## Third Party Planning Objection

Third Party planning objection vs South Dublin County Council planning application, reg. ref. SD22A/0466, which comprises of a planning application for permission for development including: "Demolition of an existing single storey plus dormer three bedroom dwelling house and the construction of four two storey three bedroom semi-detached dwellings; Three separate vehicular accesses are to be created off Templeville Drive with one to the south and two to east of the site with all ancillary site works and landscaping" at 124, Templeville Drive, Templeogue, Dublin 6w.

This objection has been produced by bps for and on behalf of Mr & Mrs Anthony Holden of No. 122A Templeville Drive, Templeogue, Dublin 6w.

**Fig 2. Proposed diversion.**

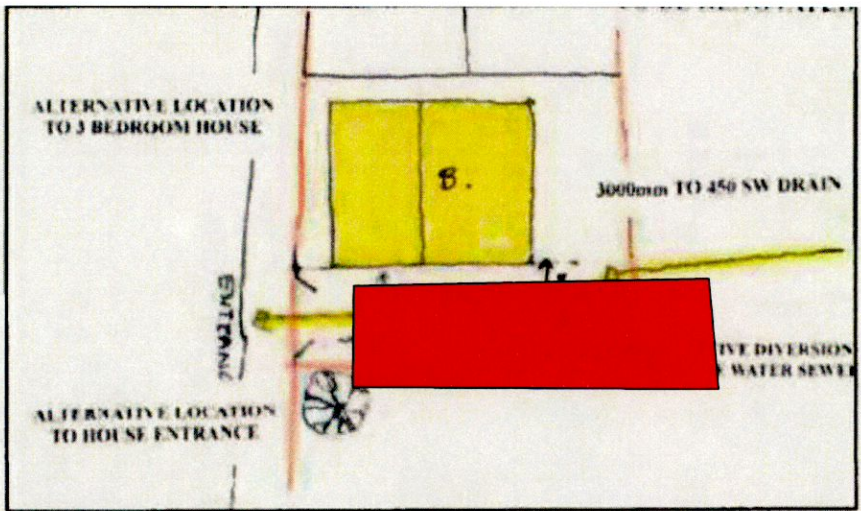
The submitted Civil & Structural Report accepts that there is a concrete culvert sited to the north side of the Applicant site but recommends that it be diverted to facilitate this proposal (see Fig. 2 of that report). Various arguments are made pertaining to the existing drainage pipe. In the end these arguments boil down to the following sentence: **"It is our opinion that the council in this case is being unreasonable in not agreeing to the diversion of the drain"** [emphasis added].

The central reason why SDCC should not agree to this proposal would pertain to the need for maintenance vehicles and machinery to get into the drain. The standard area agreed as being required is 6m wide. The Applicant's new proposals provide far less area for such access than did planning refusal SD20A/0190 & appeal ref. ABP-308456-20.

Our client does not understand how House 4 can be proposed in this context. Further, the siting of House 4 as proposed means that House 3 is necessarily pushed too close to Houses 1 and 2. Previous planning applications have proposed a single dwelling to the rear and each time they have been refused as being too close to No. 48 Templeville Road or too close to the existing dwelling and/or the previously granted dwelling to the side garden of the existing dwelling.

Fig. 2: Clarifying the areas of No. 122A which are 1 or 2 storey

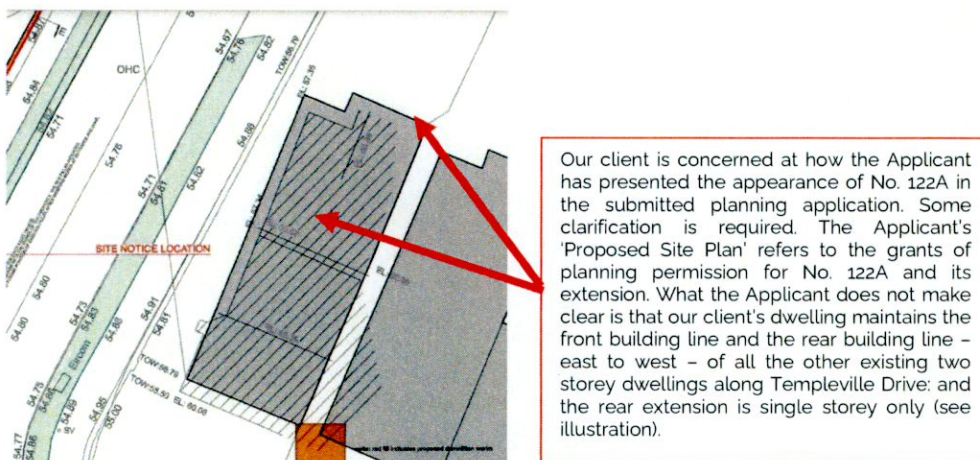
Our client is concerned at how the Applicant has presented the appearance of their property - No. 122A in the submitted planning application. Some clarification is required. The Applicant's 'Proposed Site Plan' does not refer to the grants of planning permission for No. 122A and its extension. The Applicant does not make clear is that our client's dwelling maintains the front building line and the rear building line - east to west - of all the other existing two storey dwellings along Templeville Drive: and their rear extension is single storey only (see Figs. 2 to 5).

Fig. 23: Depth of House 1's rear garden

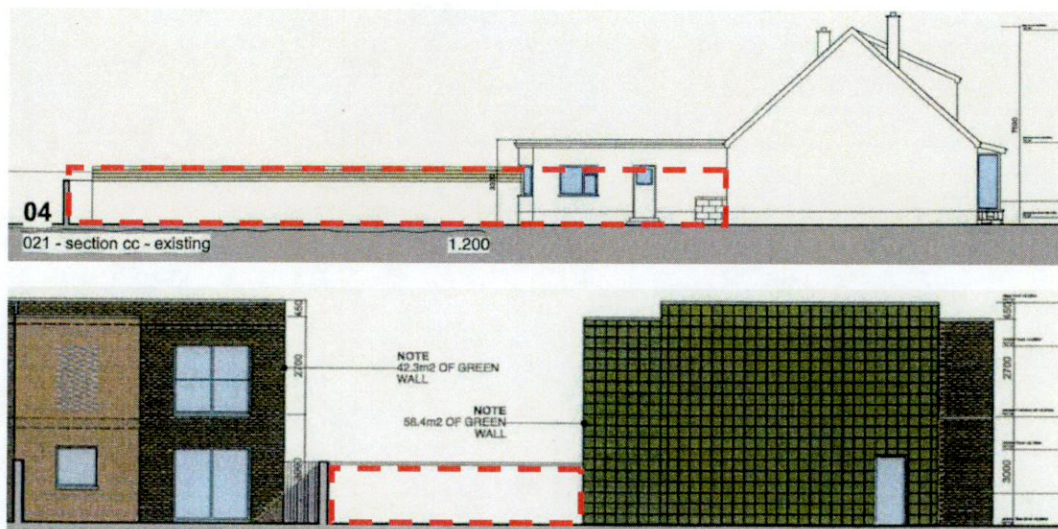
- 3 no. of the Applicant dwellings fail to offer even the minimum standard for rear garden sizes for 3 bedroom dwellings.
- All the dwellings have rear garden depths which are below a standard which can mitigate negative overlooking impacts: (i) House 1 negatively overlooking the rear gardens of Houses 3 and 4; and (2) House Nos. 3 and 4 overlook private rear gardens to the rear. The optimum rear garden depth requires at this location is 11m. Failing this, the rear garden depths should be between 7m and 11m where no negative overlooking arises and/or where it can be mitigated. These considerations do not arise in this case as the proposed designs would cause excessive negative overlooking of internal and external private rear gardens.
- The rear garden depth of House 2 is so minimal that its own outlook to the rear would be deficient facing a blank wall and the parking space of House 3.

The proposed development would materially contravene the minimum private open space standards as set out in the SDCC CDP 2022-2028. The dwellings would offer future residents a deficient level of amenity while impacting negatively on adjoining properties by way of overlooking.

Fig. 27: The compromised siting and design of House 2 (first floor level)

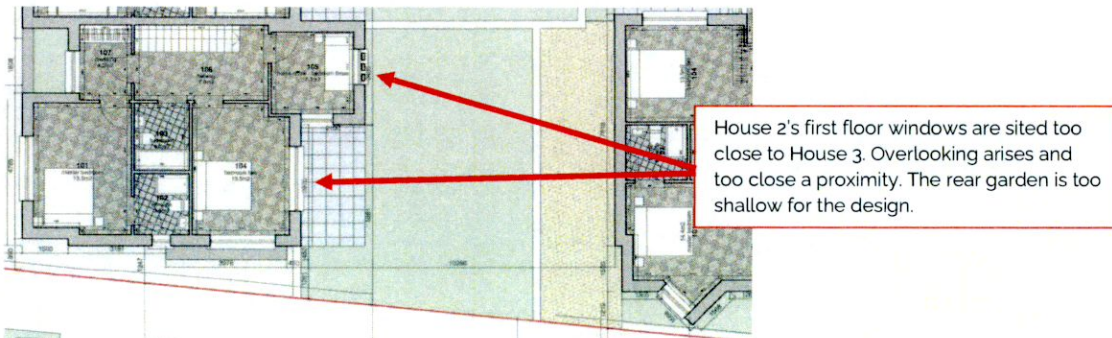
For the reasons given above, the proposed development would be contrary to Section 12.6.8 'Corner / Side Garden Sites' of the SDCC CDP 2022-2028. The proposed development represents overdevelopment of the subject site.

**Fig. 28: The proposed building line & the established building line to front**

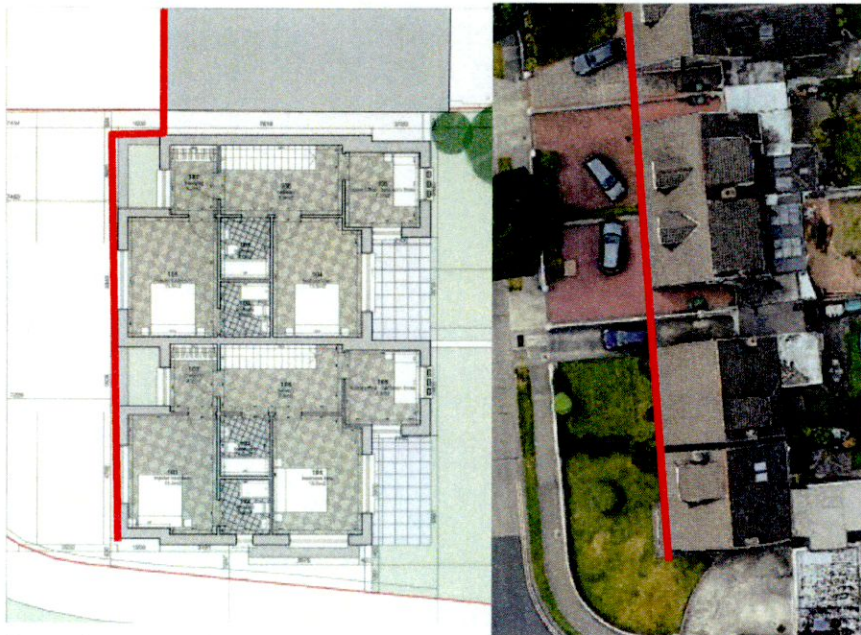
The Applicant is also trying to create a new building line to the front of the Houses 3 and 4 where there is none at present excepting the sides of the existing dwelling and that the north. The proposed building line appears to have no relationship to any likely building line which may arise in the future if the property to the north develops a house in its side garden (see Fig. 29).

Fig. 32: First floor windows directed toward client property

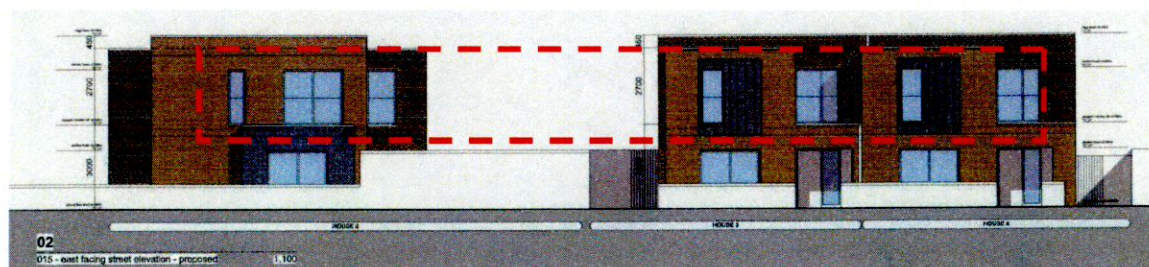
The Applicant Planning Report seeks to argue away these negative impacts but fails to do so. The design seeks to install 2 storey dwellings on an east-west axis adjoining private rear gardens on 3 sides and sited opposite a 4th private garden to the east. A backland proposal cannot be 2 storeys at such a sensitive location. The overlooking impact arising is not "negligible" it is significant. The Applicant architect should have undertaken pre-planning with SDCC and/or worked with a planning consultant to address this.

**BPS concludes that the proposed development cannot be permitted as submitted. It needs to be refused such that significant revision to address negative overlooking concerns can be addressed.**

Fig. 37: Overshadowing of client's rear garden in late afternoon on 21<sup>st</sup> March and 21<sup>st</sup> September

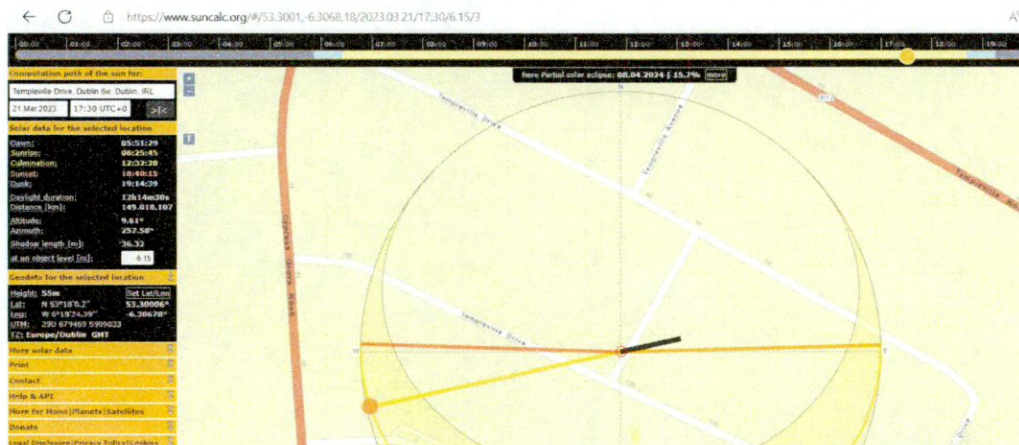
The cumulative extent of negative overshadowing of adjoining and neighbouring private open spaces arising is unacceptable and cannot be justified. Two storey dwellings cannot be sited at this backland location without impacting negatively on our client's private garden, the adjoining properties to the west and north, and on proposed House 1. Houses 3 and 4 are also designed such that they would overshadow each other and overshadow their own gardens in the mornings. Houses 3 and 4 constitute overdevelopment of the backlands of the site which causes negative overshadowing in a manner which means they should be refused.

Fig. 47: Proposed proximity of 'House 1' to No. 126

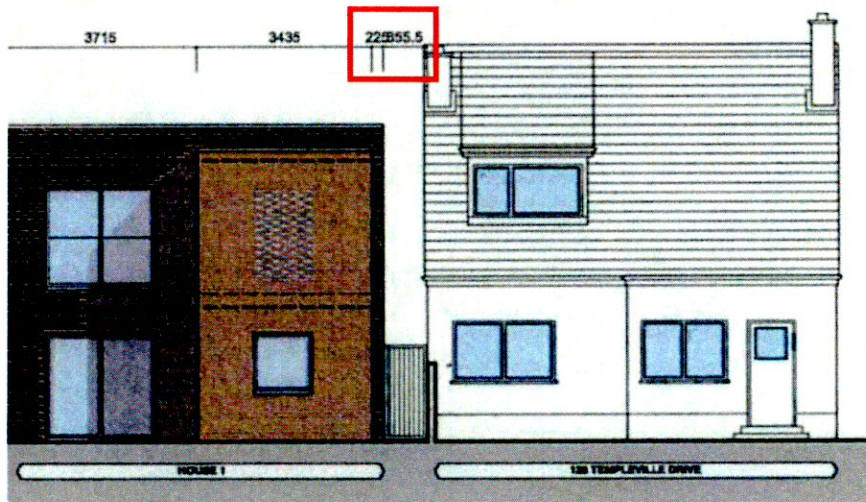
Arising from the decision to propose to demolish No. 126, the Applicant is proposing a setback between the new proposed dwelling 'House 1' and No. 126 of just 85,55cm. This setback is not sufficient to mitigate the visual impact of demolishing the existing dwelling (one of the pair) and relacing it with a new flat roofed contemporary dwelling. While the existing pair of dwellings are close together, this is possible because they read much as a semi-detached dwelling does. They read almost, that is, as one. Placing two wholly different designs side by side and so close would cause a visual clash that would detract from the streetscape.
